Site Accessibility Evaluation

Fair and Events Complex

**366 10th St
Calhan, CO 80808**

Inspection Date: 10/29/2015

Finding: 2

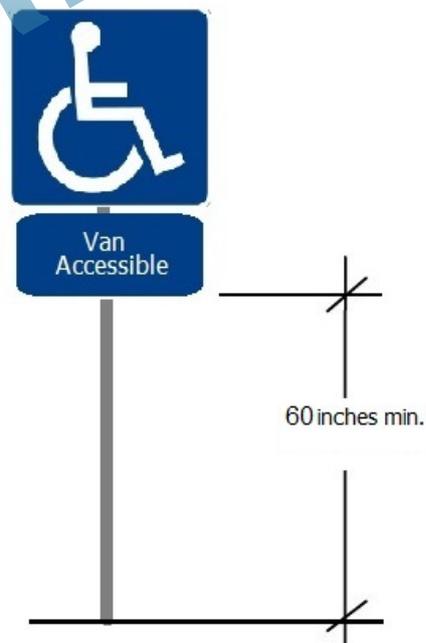
The parking sign/s are missing.

Accessible parking not identified.

Have a van accessible parking spot and access aisle marked, and sign installed

Finding: 6

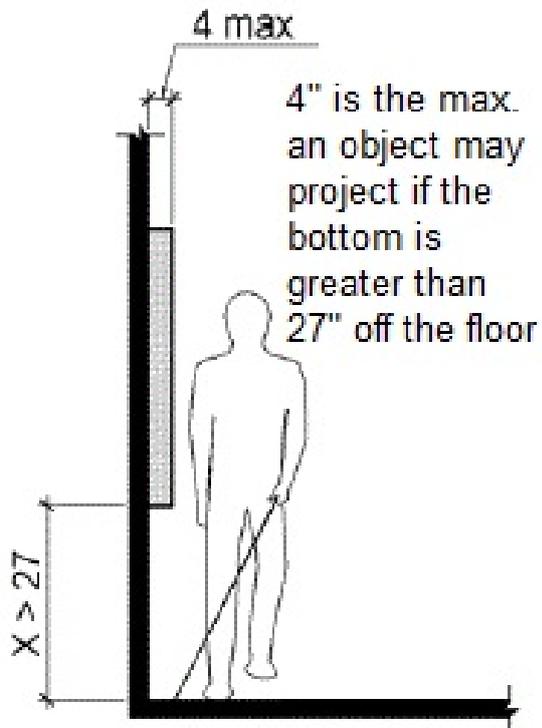
The AED housing projects more than 4 inches into the circulation path.

AED housing
protrudes 7 inches

If possible, replace AED housing with low profile housing or recess housing into wall to meet the 4 inch maximum protrusion or place AED away from circulation path.

Finding: 7

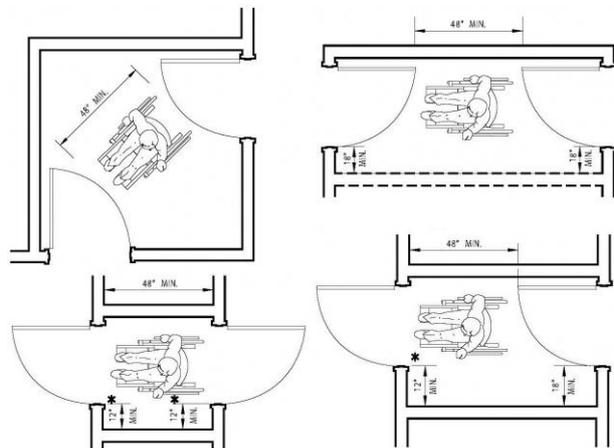
The maneuvering space between the two doors in the vestibule is noncompliant.

29.5 inches between the two doors in the vestibule.

Several options to meet compliance:

1. Remove inner doors
2. Change door swing of inner doors
3. Add automatic door openers to ensure outside and inner doors open simultaneously.

Finding: 13

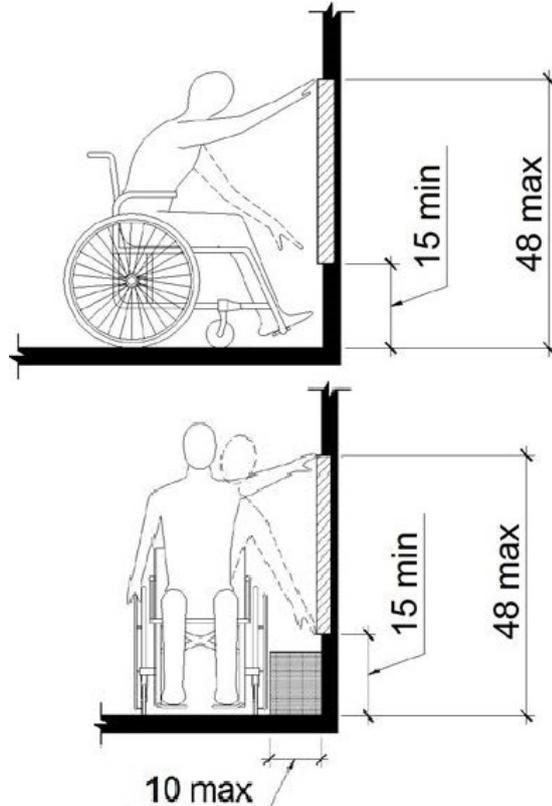
The baby changing table operating mechanism is outside reach range.

57 inches above finished floor

Remove and replace existing baby changing station with horizontal baby changing station. Ensure there is a 27 inch knee clearance measured from the finished floor to the bottom edge of the baby changing station and the operable part at a maximum of 48 inches measured from the finished floor.

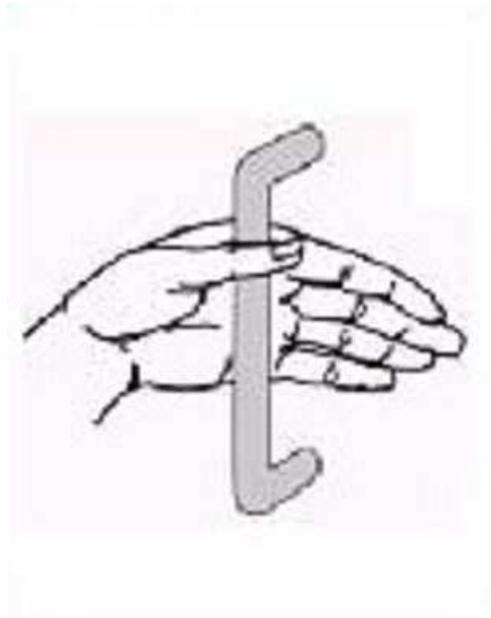
Missing loop handle
on outside of
compartment door

Install loop or U-shaped handle on outside of compartment door.

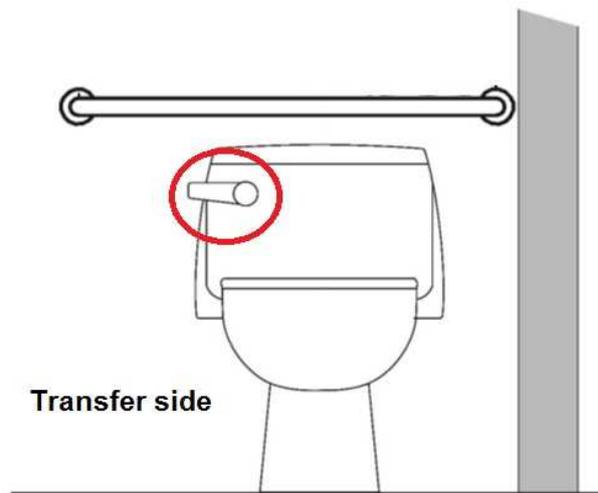
Flush handle located on transfer side of toilet

Replace toilet water tank with one that has flush handle on the opposite side (open side of toilet area).

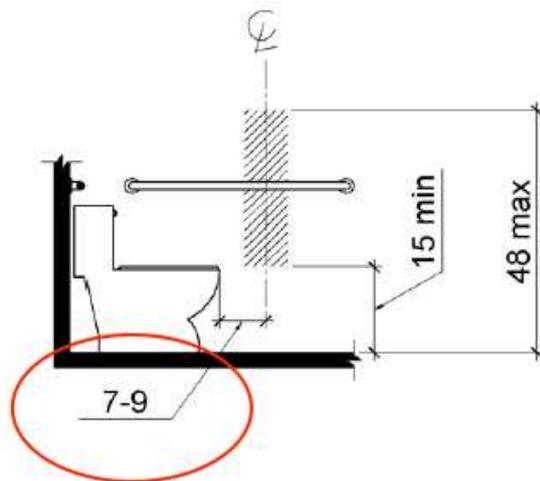
1 inch in front of toilet

Re-position toilet paper dispenser to be within 7 inches minimum to 9 inches maximum in front of the toilet measured to the centerline of the dispenser.

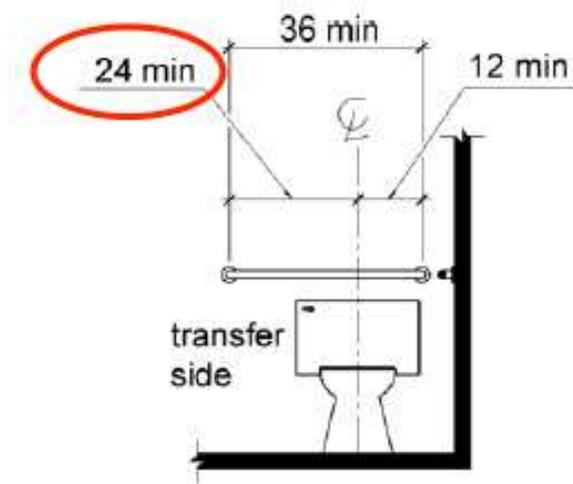
21.5 inches from centerline of toilet

Re-position rear grab bar to extend from the centerline of the toilet 12 inches minimum on wall side and 24 inches minimum on the wide side.

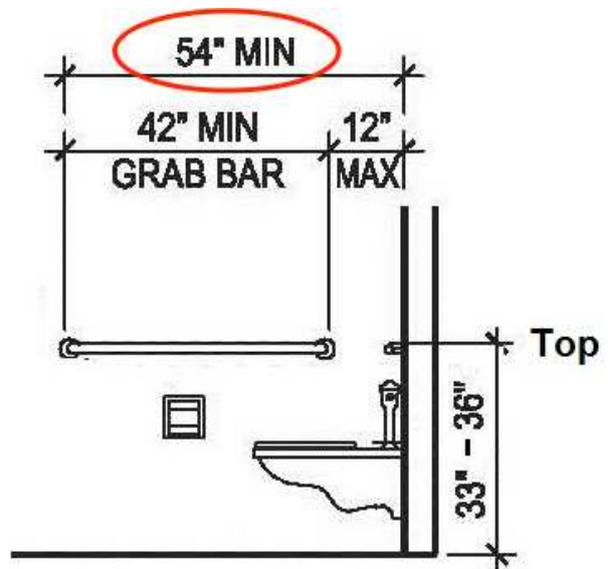
49 inches from rear wall

Adjust side grab bar no to exceed 12 inches from rear wall. The side grab bar must extend at least 54 inches minimum beyond the rear wall.

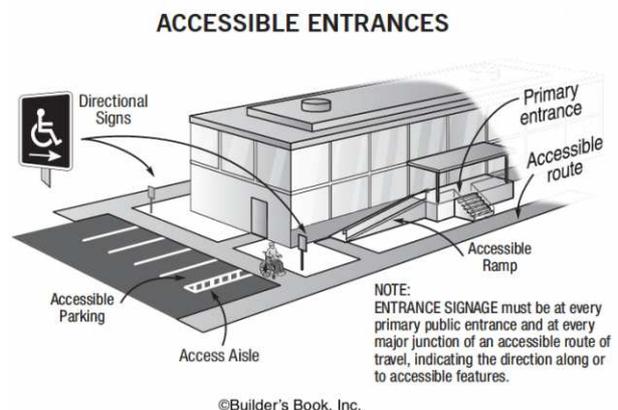
No accessible entrance to play structure

No accessible entrance to playground. Recommend installing an ADA ramp as used in school playgrounds or construct concrete ramp.

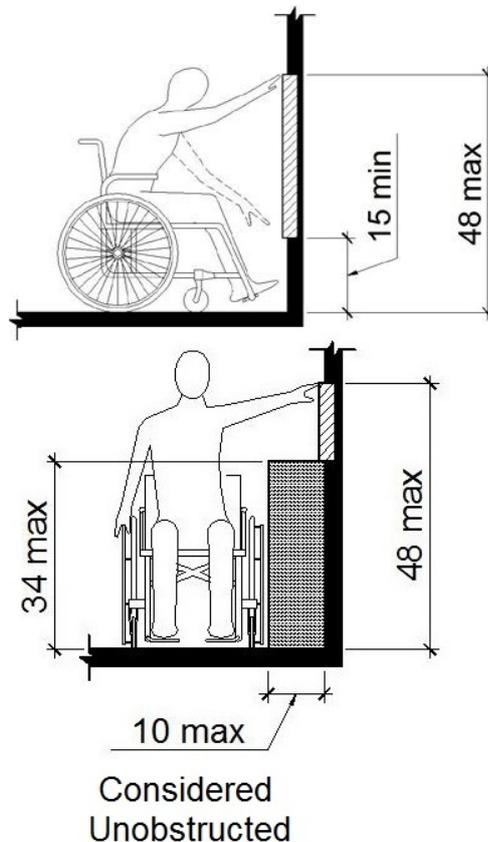
60.25 inches above finished floor

Lower coat hook 15 inches minimum. Not to exceed a maximum height of 48 inches above finished floor.

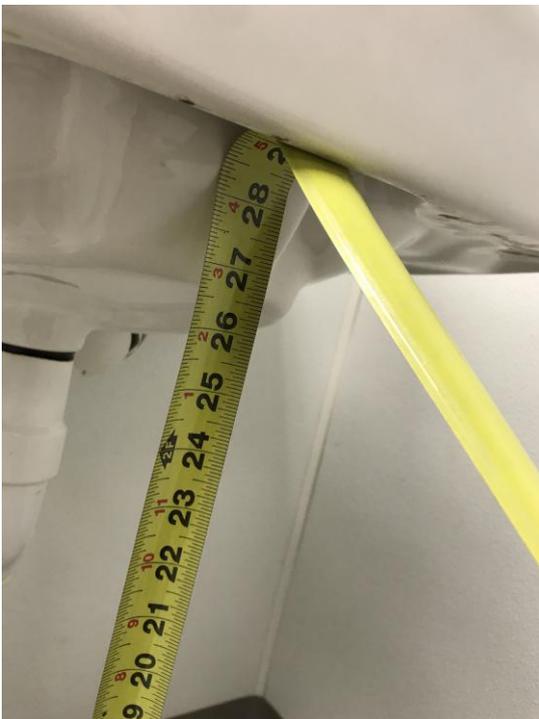
No knee clearance provided under lavatory

Replace lavatory with one that provides a minimum height from the bottom edge of no less than 27 inches above finished floor and 8 inches minimum in depth for knee clearance.

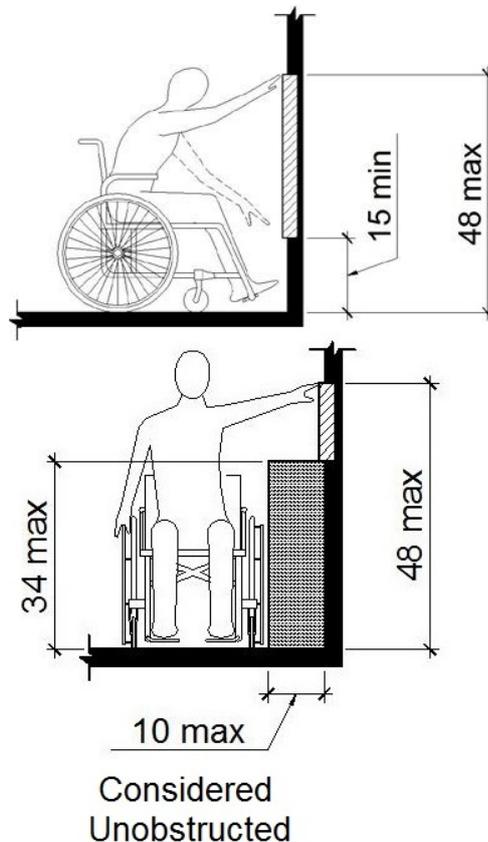
67 inches above finished floor

Lower coat hook 20 inches minimum. Not to exceed a maximum height of 48 inches above finished floor.

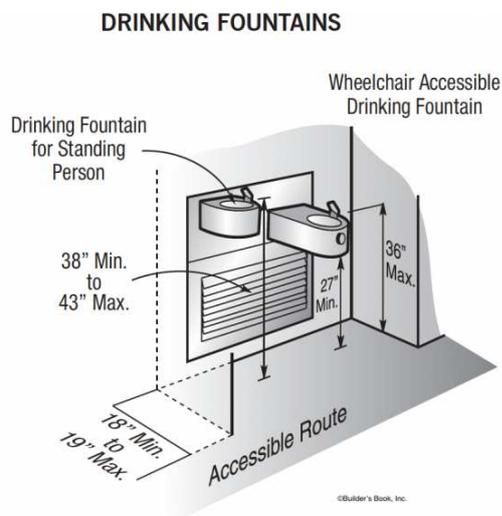
Non compliant

Replace existing drinking fountain with a HiLo drinking to meet ADA compliance. Ensure knee compliance is met and set at 27 inches exactly from bottoe edge of drinking fountain to finished floor.

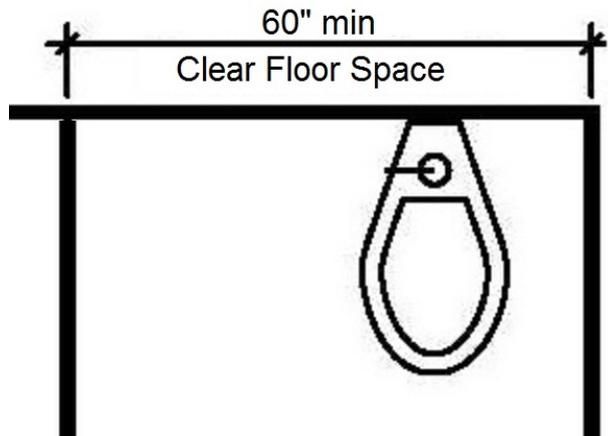
32 inches wide

Remove adjacent toilet to make toilet compartment compliant (check building code) or install directional signage outside of restrooms informing public of accessible restrooms locations.

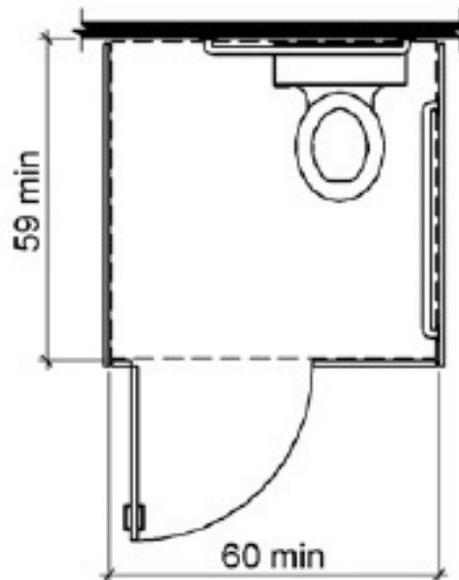
55.5 inches deep

Remove adjacent toilet to make toilet compartment compliant (check building code) or install directional signage outside of restrooms informing public of accessible restrooms locations.

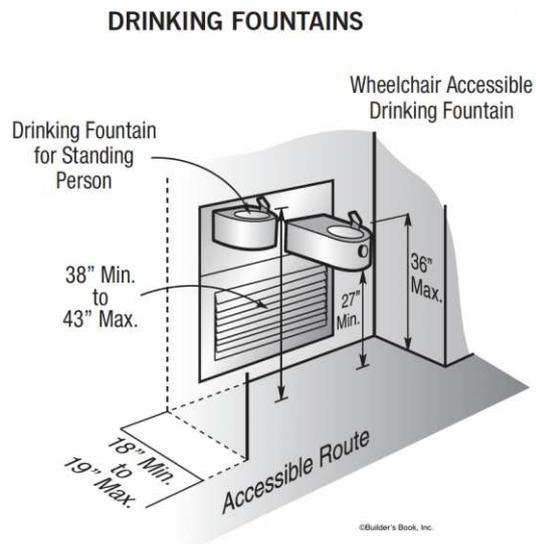
Out order and non compliant

Remove fountain. Water piping inside concrete walls permanently damaged.

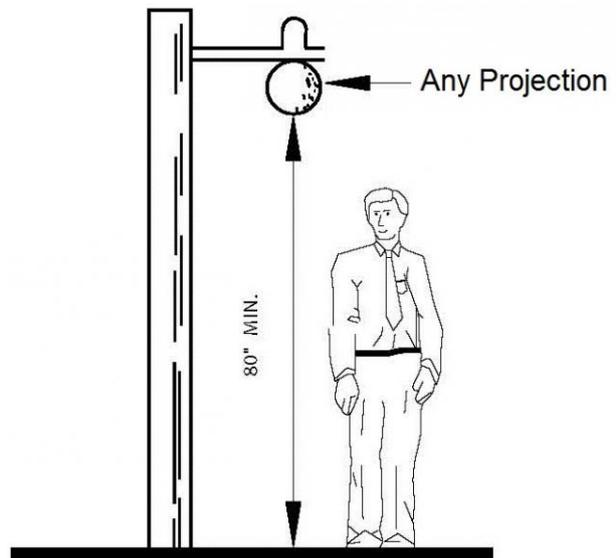
64 inches above finished floor

Reposition shelf height to ensure any protrusion of 4 inches or more is at 80 inches minimum above finished floor.

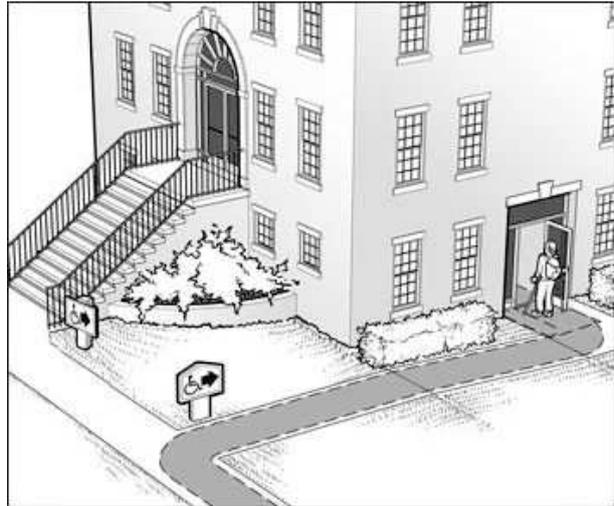
Obstructions
throughout path of
travel to side entrance

Remove existing obstructing elements. Also provide an accessible ramp with handrails at the entrance due to existing 8 inch curb restricting/blocking wheelchairs and other power mobility devices from entering building at main entrance.

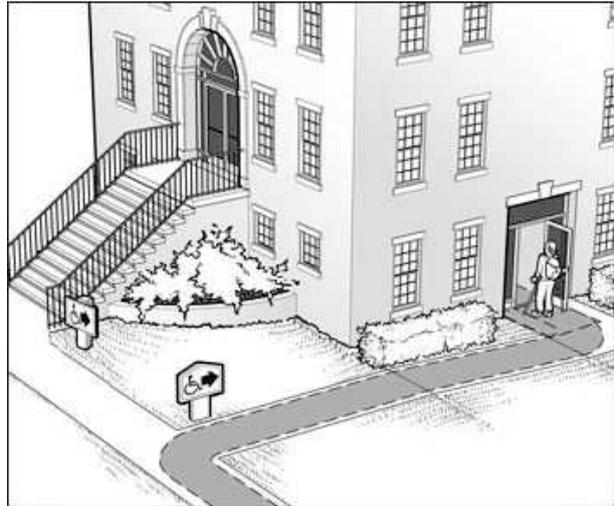
Obstructions
throughout path of
travel to side entrance

Remove existing obstructing elements. Also provide additional turning space at side entrance in front of doors due to doors blocking the circulation path. Ensure additional turning space is firm, stable and slip resistant.
